ADDENDUM THREE

Project No.: **23-072**

Subject: **CHANGES to the BIDDING DOCUMENTS**

Project: **EXTERIOR PEDESTRIAN BRIDGE REPLACEMENT PROJECT FOR
ORANGEVILLE CUSD #203
ORANGEVILLE, ILLINOIS**

SHEET NUMBER S001 OF 2

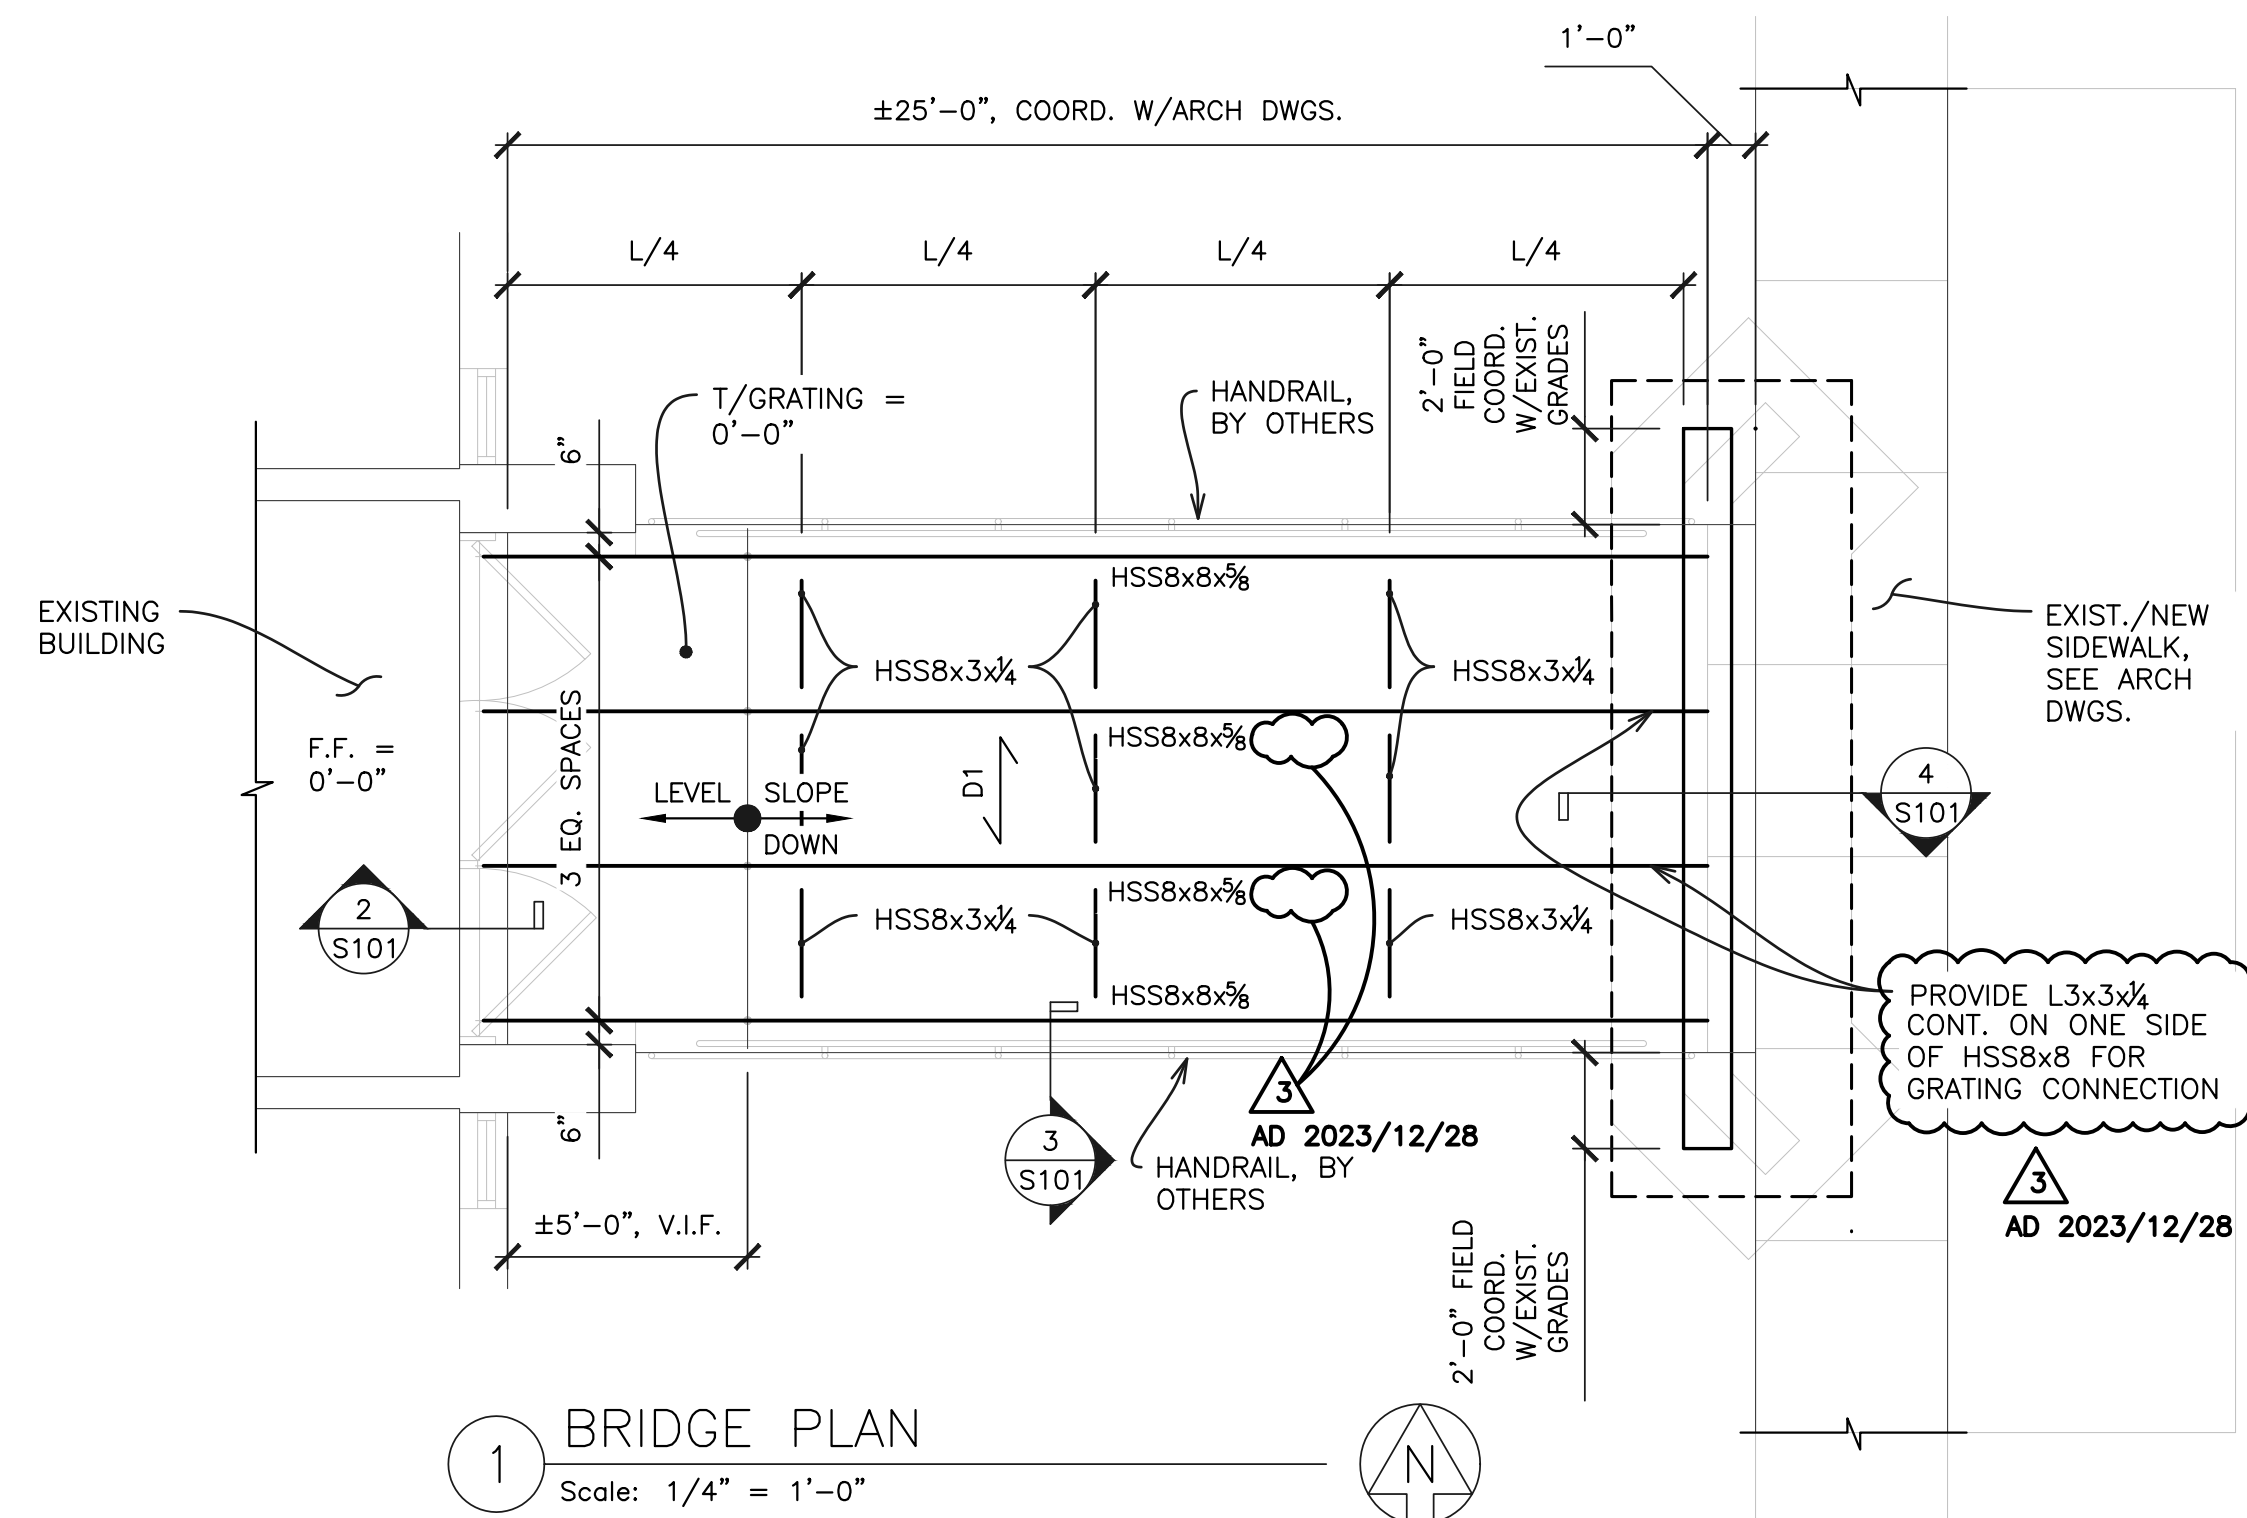
2.1. Structural Steel Item 9: replace note with Refer to architectural drawings and specifications for steel finishes.

1 BRIDGE PLAN
Scale: 1/4" = 1'-0"

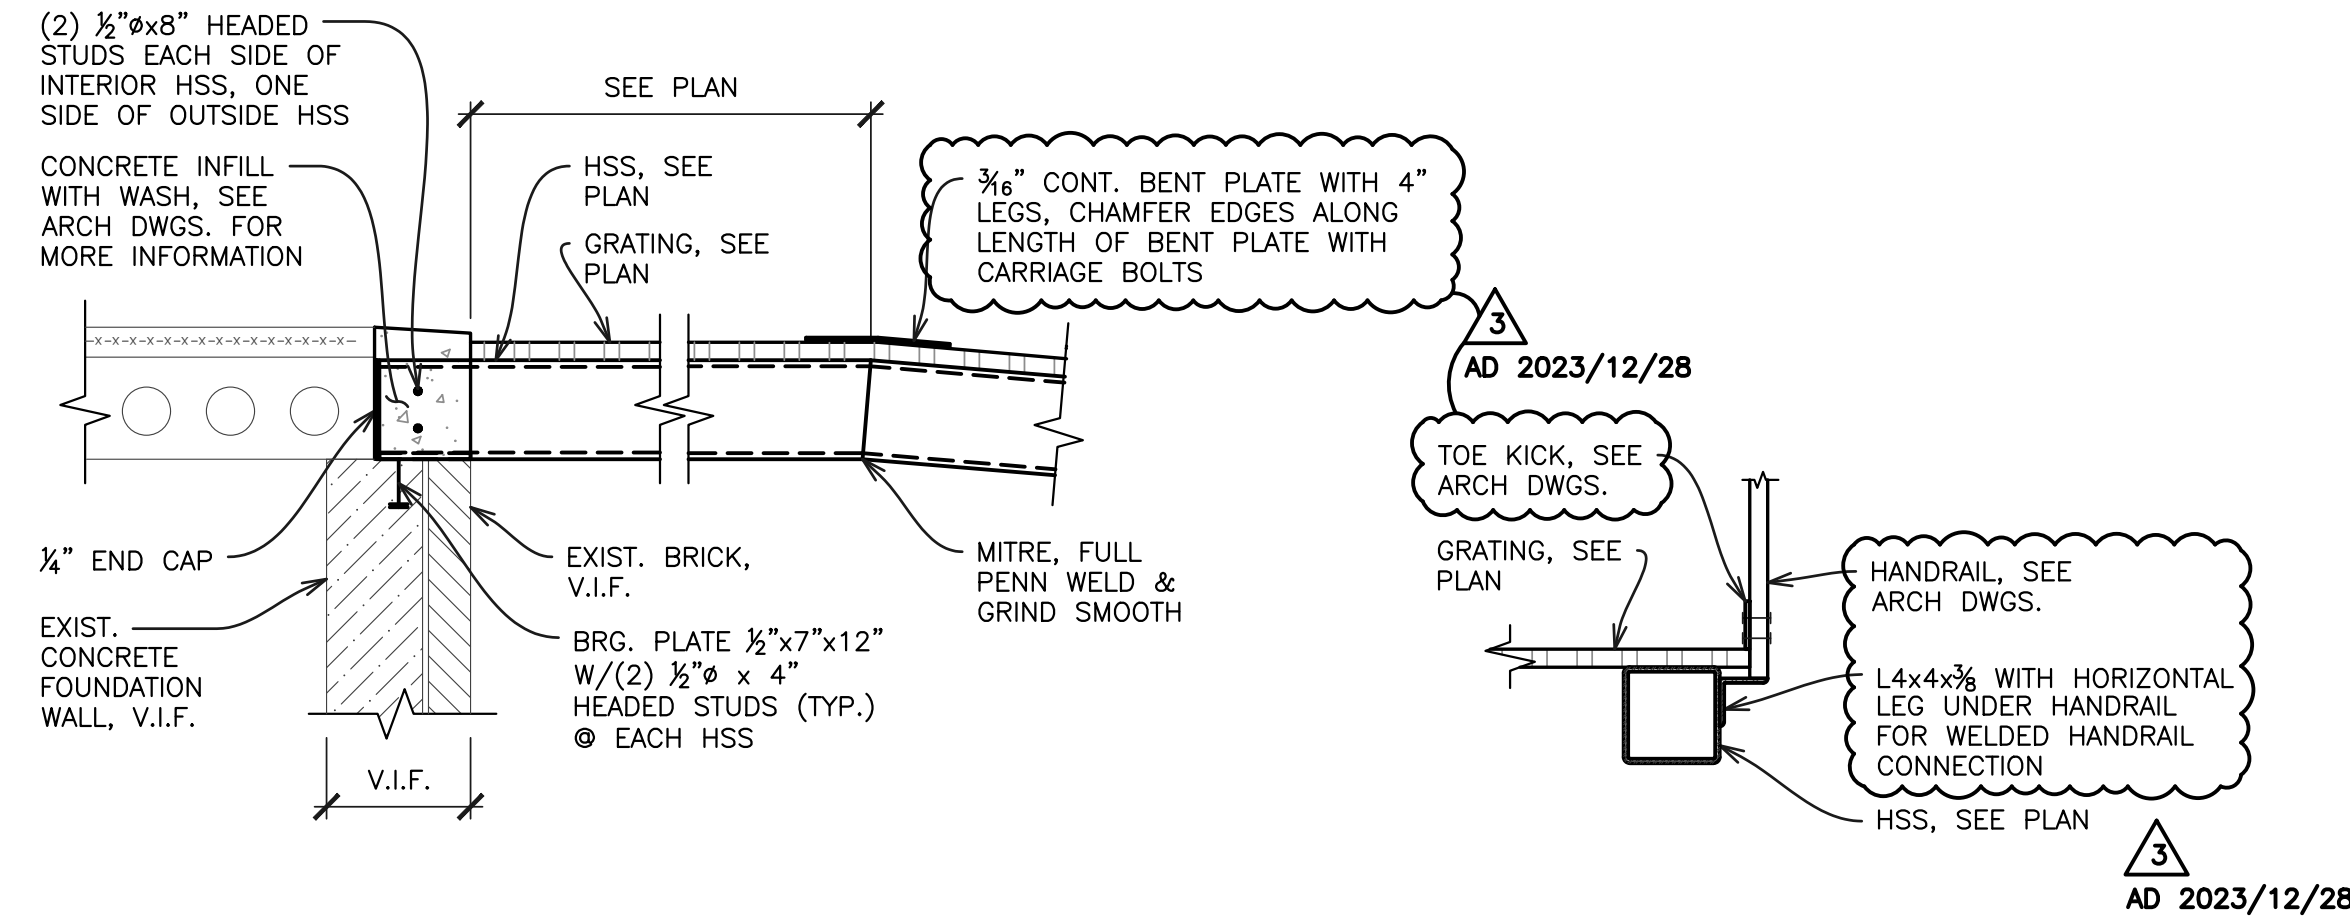
3.1. Bridge Plan 1: omit the (+3/8) at the two interior HSS8x8x5/8"

3.2. Bridge Plan 1: add L3 x 3 x 1/4" x cont. angle on one side of the two interior HSS8x8 for connection of grating.

2 SECTION
Scale: N.T.S.

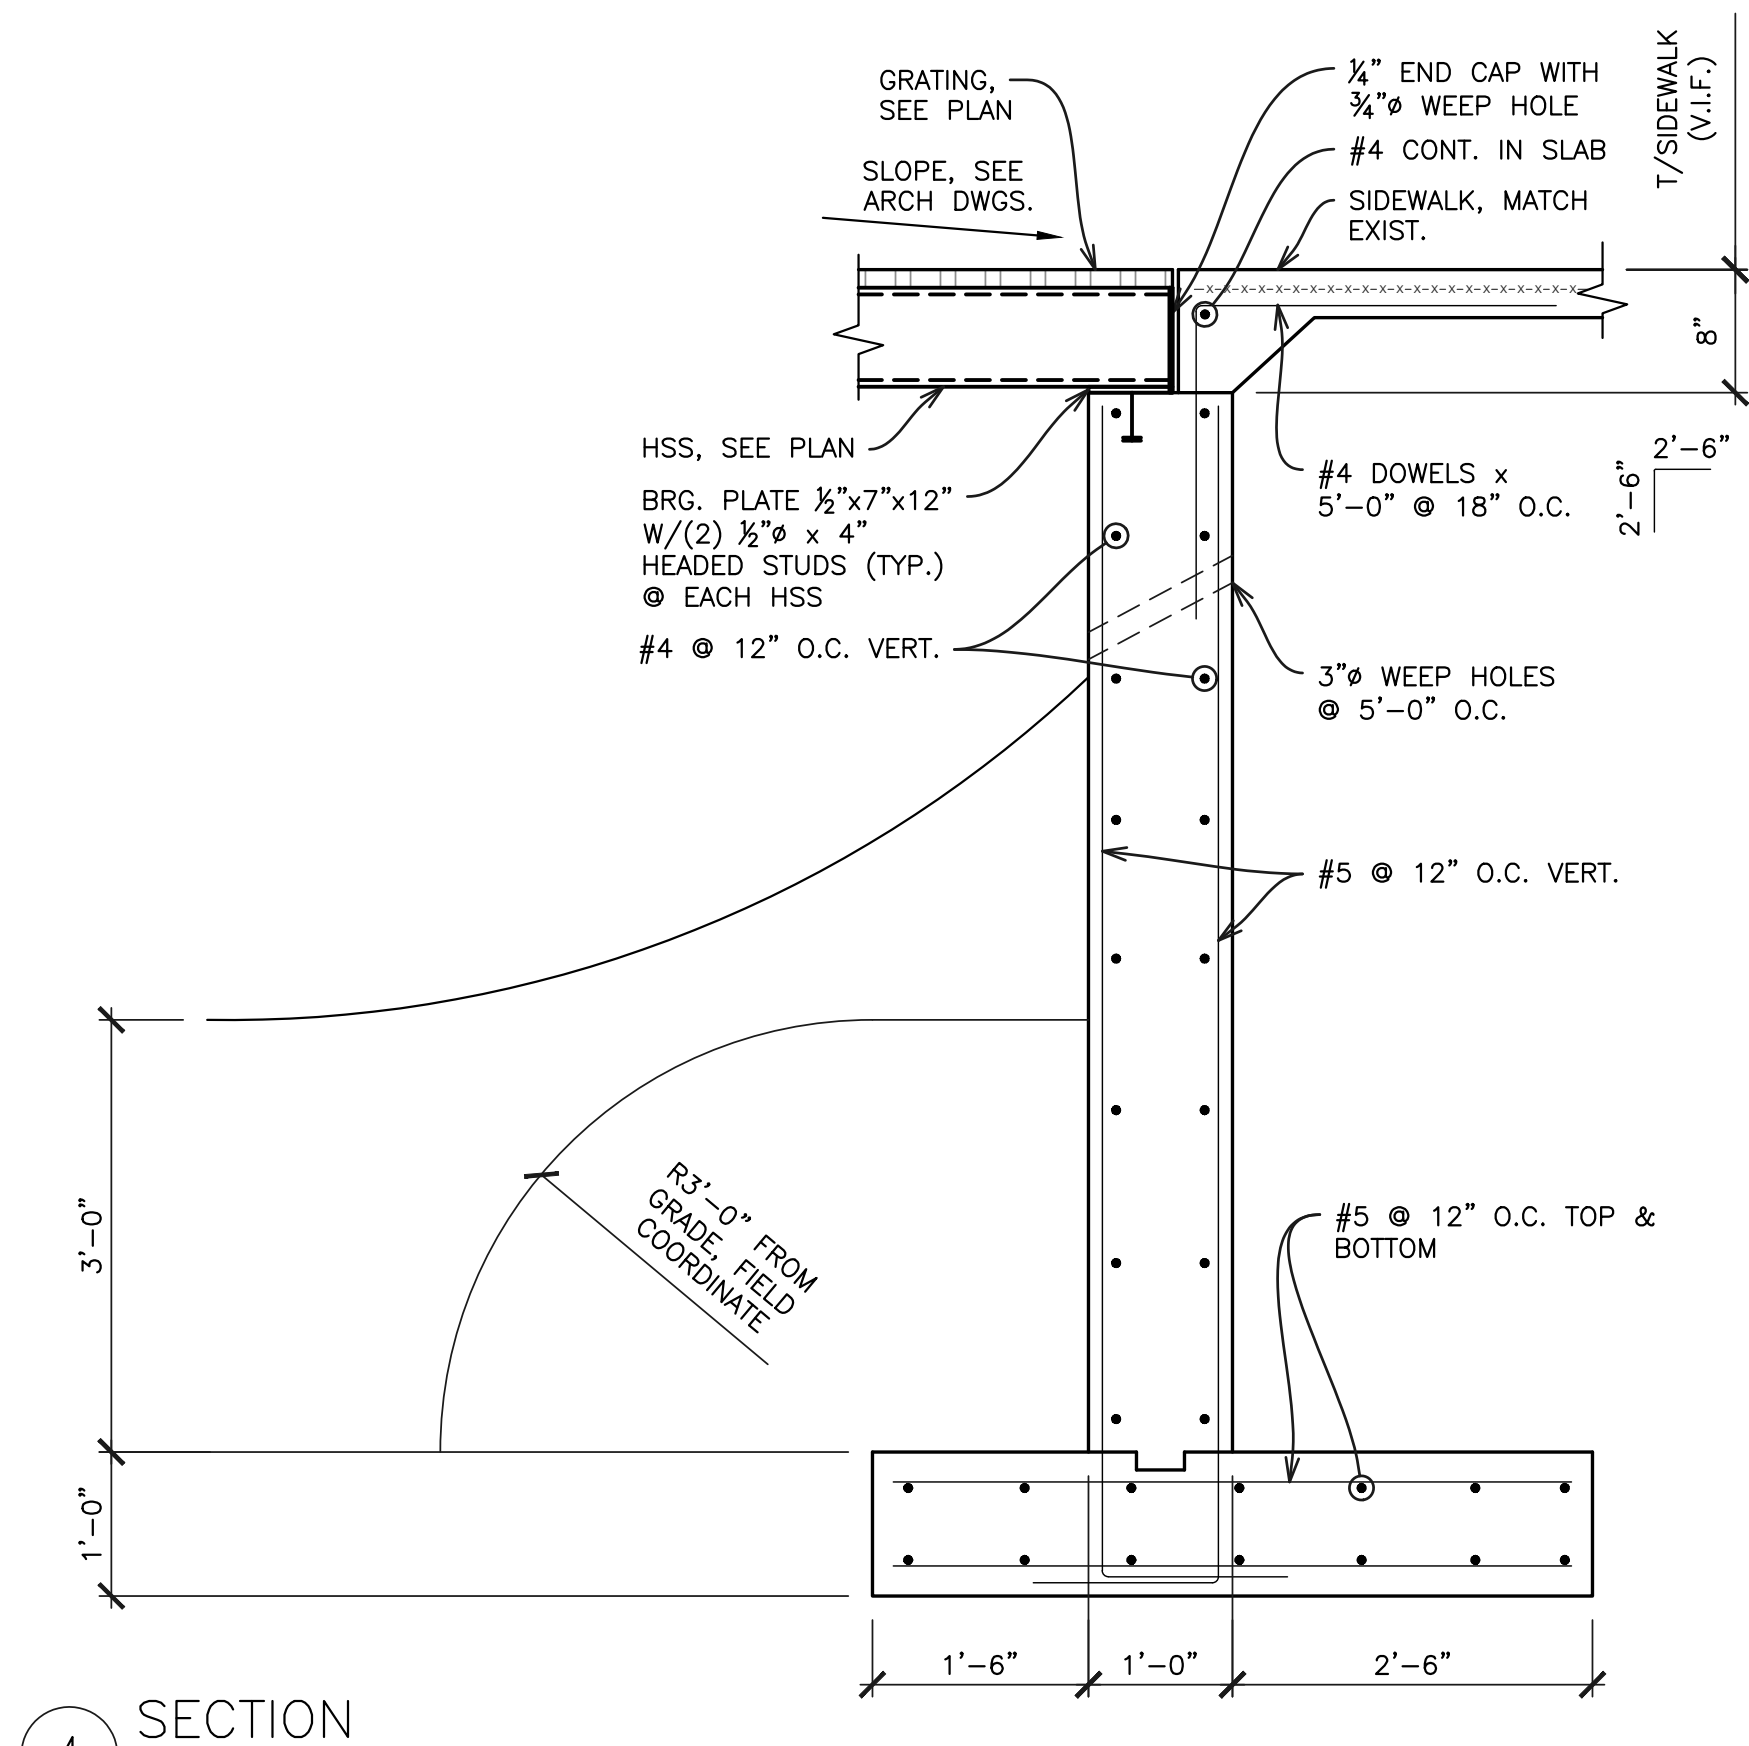
3.3. Detail 2: Add 3/16" bent plate with 4" legs at the transition from the "level" to the 'slope down'. Bolt to supporting structure with carriage bolts. Chamfer both long edges of plate. The bent plate shall extend the full width of the bridge.

6 DETAIL
SCALE: 1-1/2"=1'-0"

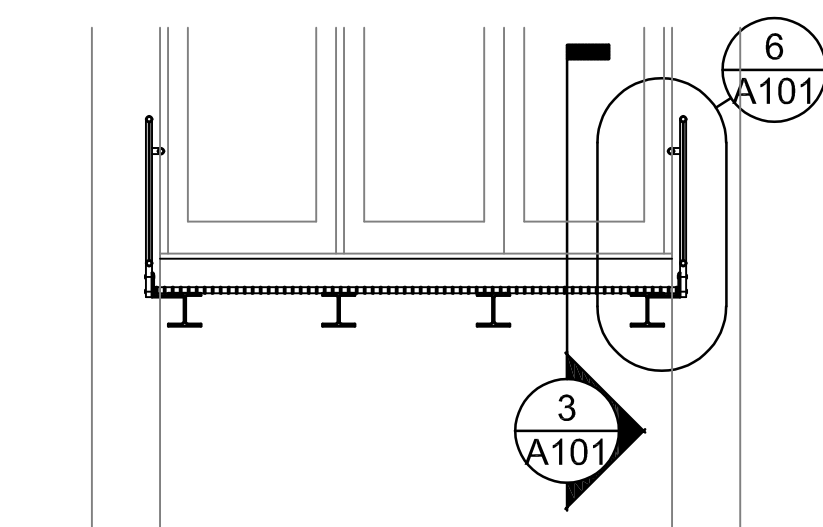
4.1 Detail 6/A101: Revised to match Detail 3/S101.
